<b>Concerned Products:</b>	<b>Customer Notification</b>	Date: Nov. 8, 1999
<i>μPD703033</i> <i>μPD703033Y</i> <i>μPD70F3033</i> <i>μPD70F3033Y</i>		NEC-Electronics (Europe) GmbH EAD –Technical Product Support
<b>Bug Report</b>		Source Doc: HW 260199 HW 080299 SBG-T-1719 SBG-T-1777
		Author: H.-W. Hoefft, Udo Wenzel
Date of initial issue: Feb 19 <sup>th</sup> 99		Doc. No.: TPS-HE-B-2120

**(A) BUG LIST**

**(B) BUG DESCRIPTION**

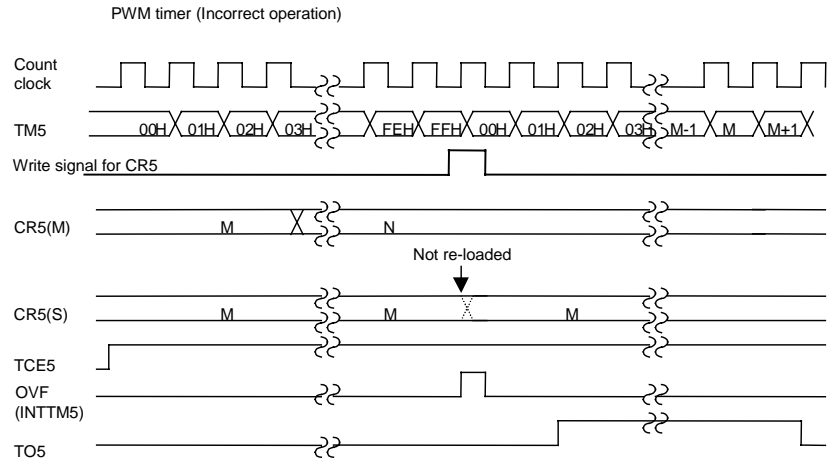
<p>3</p>	<p>TM 2-5 operational defect</p>	<p><u>Details:</u></p> <p>When used in interval timer mode          If the compare register (CR20-50) is written when the timer register (TM2-5) and compare register (CR20-50) coincide, a coincidence signal is not generated. For this reason, the software must be designed to prevent timer coincidence and writing the compare register occurring at the same time. (Example: use a Vector interrupt)</p> <p>When used in square wave output mode          If the compare register (CR20-50) is written when the timer register (TM2-5) and compare register (CR20-50) coincide, a coincidence signal is not generated and the output waveform does not invert. For this reason, the software must be designed to prevent timer coincidence and writing the compare register occurring at the same time. (Example: use a Vector interrupt)</p> <div style="text-align: center;"> <p>Interval timer and square wave output (Normal operation)</p>  </div> <div style="text-align: center;"> <p>Interval timer and square wave output (Incorrect operation)</p>  </div> <div style="text-align: center; border: 1px solid black; padding: 5px; margin-top: 10px;"> <p>The timing chart above is intend to show the general operation and does not show precise timing</p> </div>

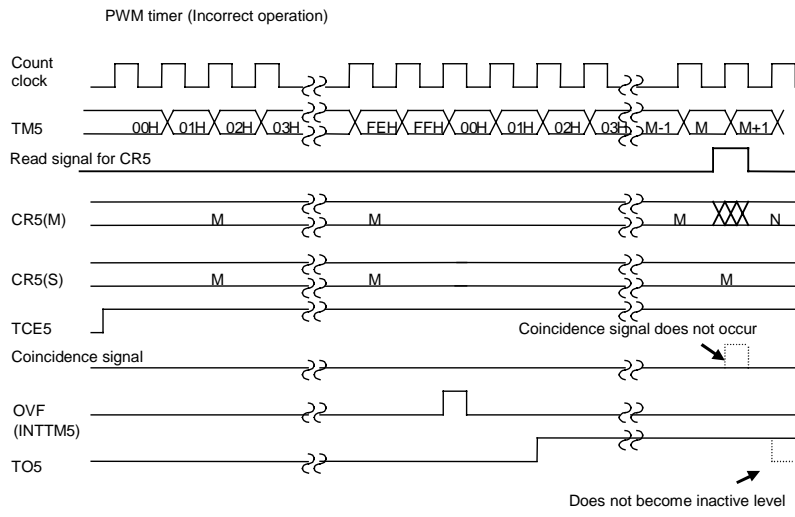
<p>3</p>	<p>TM 2-5 operational defect</p>	<p>When used in PWM output mode</p> <ul style="list-style-type: none"> <li>- If the CR20-50 (master register) is re-written at the same time as the timer register overflows when the CR20-50 (master register) is written, the expected data sometimes cannot be transferred to the CR20-50 (slave register). (Data value is undefined) The software must be designed to prevent the overflow occurring at the same time as writing in the compare register.</li> </ul> <p>PWM timer (Incorrect operation)</p> <p>Count clock</p> <p>TM5</p> <p>Write signal for CR5</p> <p>CR5(M)</p> <p>CR5(S)</p> <p>TCE5</p> <p>OVF (INTTM5)</p> <p>TO5</p> <p>Not re-loaded</p> <p>PWM timer (Incorrect operation)</p> <p>Count clock</p> <p>TM5</p> <p>Read signal for CR5</p> <p>CR5(M)</p> <p>CR5(S)</p> <p>TCE5</p> <p>Coincidence signal</p> <p>OVF (INTTM5)</p> <p>TO5</p> <p>Coincidence signal does not occur</p> <p>Does not become inactive level</p> <div style="border: 1px solid black; padding: 5px; margin-top: 10px;"> <p>The Timing chart above is intended to show the general operation, and does not show precise timing.</p> </div>

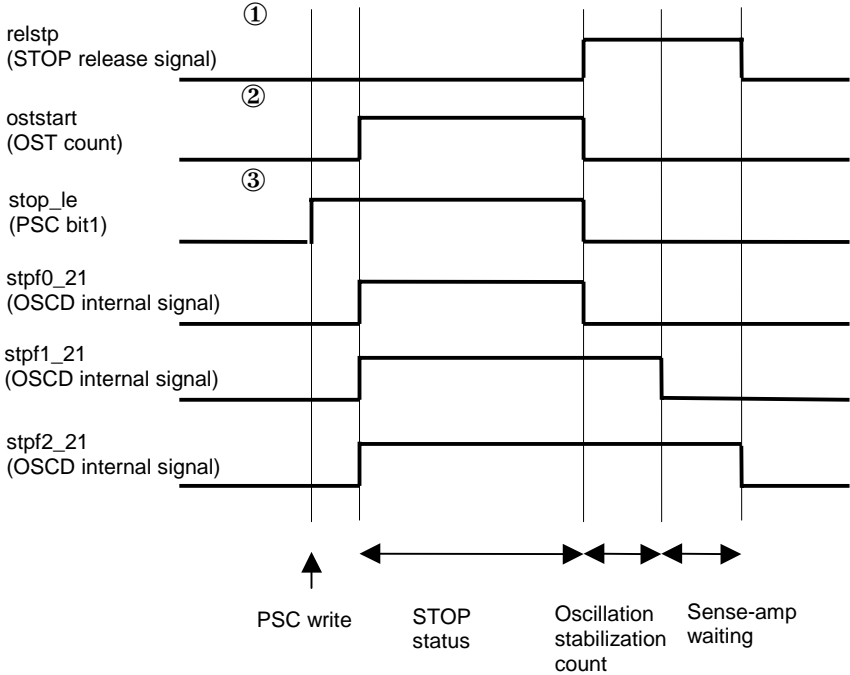
- If the compare register (CR20-50) is written when the timer register (TM2-5) and compare register (CR20-50 [slave register]) coincide, a coincidence signal is not generated and the inactive level is not attained.

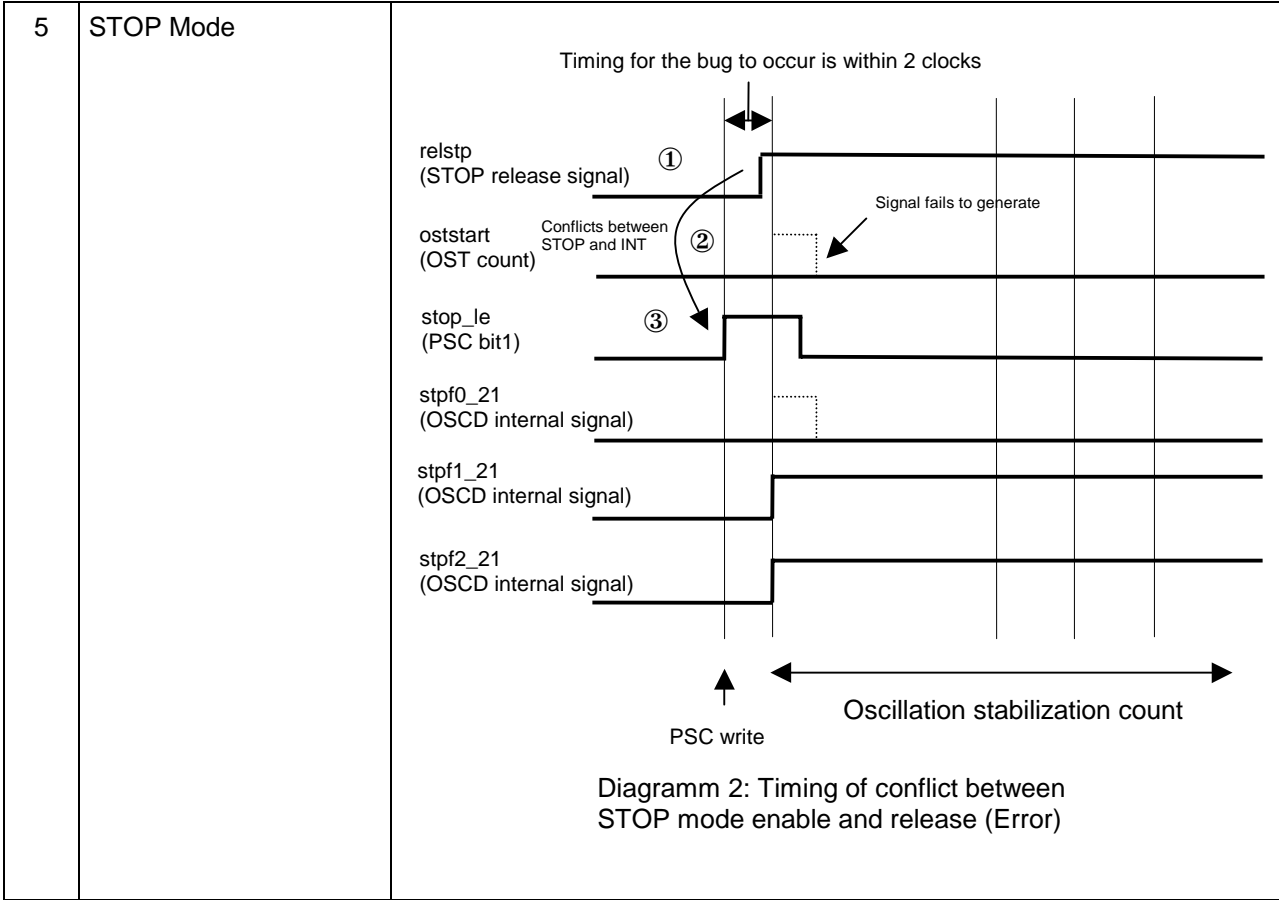
Bug No.	Outline	Description
4	Using the IIC restart condition causes a faulty address transfer.	<p><u>Details</u>                      If the transfer address is set to the shift register (IIC0) immediately after the (re)start is set (STT = 1), the transfer address will be sent simultaneously by rising edge of the serial clock (SCL).                      The serial clock is at low level normally before a restart condition will be set, due to the preceded address/data transfer. To generate a (re)start condition the serial clock (SCL) has to be first on high level (recessive state). By falling edge of the SDA line, when SCL has high level, the (re)start condition can be detected. Afterwards the SCL line will fall to low level and the slave address can be transferred by normal operation.                      Now, if the slave address is written into the shift register (IIC0) immediately after the start condition trigger (STT0) is set, the rising edge on the SCL line resulting in data output before the start condition is set. This causes the bug.</p> <p><u>Workaround</u>                      The transfer address must be set after the confirmation of start condition detection (STT=0, STD = 1).</p>  <pre>                     graph TD                         Start([Start]) --&gt; Set[Set (re)start condition STT0 = 1]                         Set --&gt; STT0{STT0 = 0}                         STT0 -- NO --&gt; Wait1[wait until the start condition has been accepted]                         Wait1 --&gt; STT0                         STT0 -- YES --&gt; STD0{STD0 = 1}                         STD0 -- NO --&gt; Wait2[wait until the start condition has been detected]                         Wait2 --&gt; STD0                         STD0 -- YES --&gt; Write[Write transfer address to IIC0 register.]                         Write --&gt; End([End])                     </pre>
